ADDENDUM No. 3 Request for Competitive Sealed Proposals (CSP) 19CSP105 Renovations at Pecan Springs Elementary School

February 15, 2019

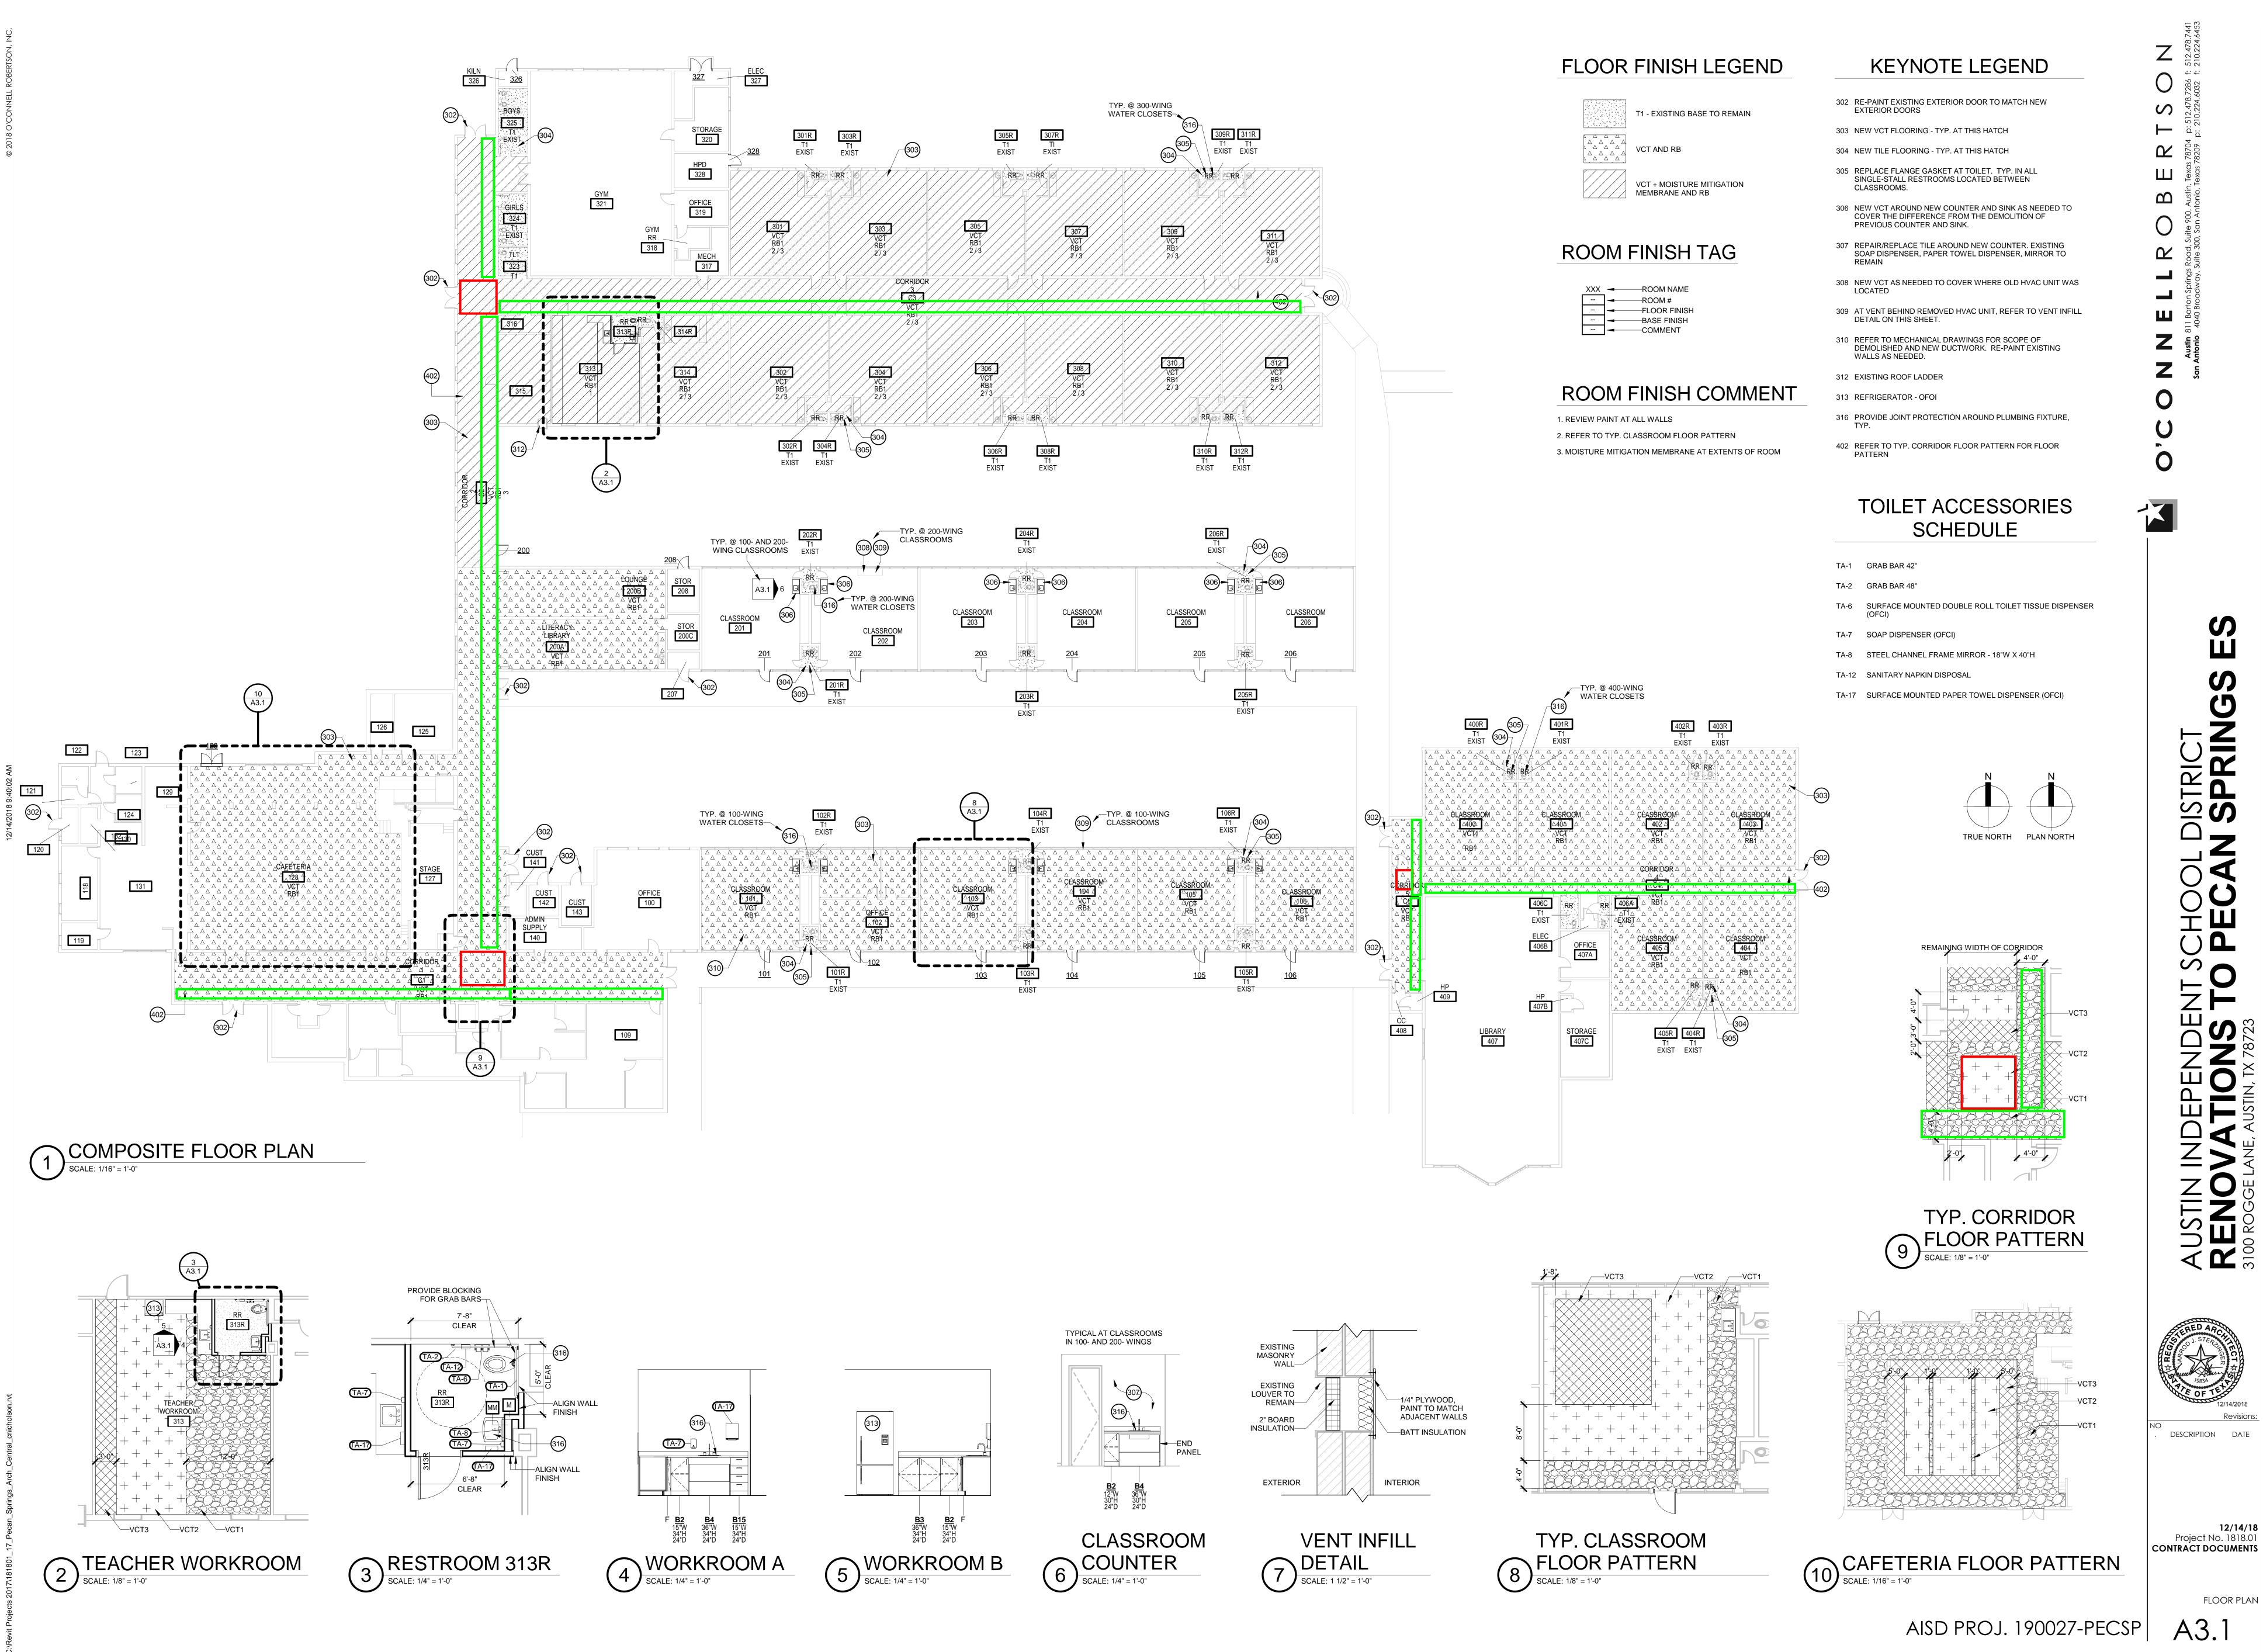
3) There is there a total of 12 new RTU Units going on the 100 and 200 wing and then two new condensing units on the 300 wing is that correct? On the plans it just has RTU 2 and 8 marked as new RTU curbs and units. When I was at the pre-conference and looked at the roof those the 100 and 200 wing did not have any RTU on them. If you could just clarify if all the RTU 1-12 are new curb and units or if they are just new curbs for RTU 2 and 8?

• It's all of the units. RTU 2 and 8 are just shown as a typical but each room has a note referencing them.
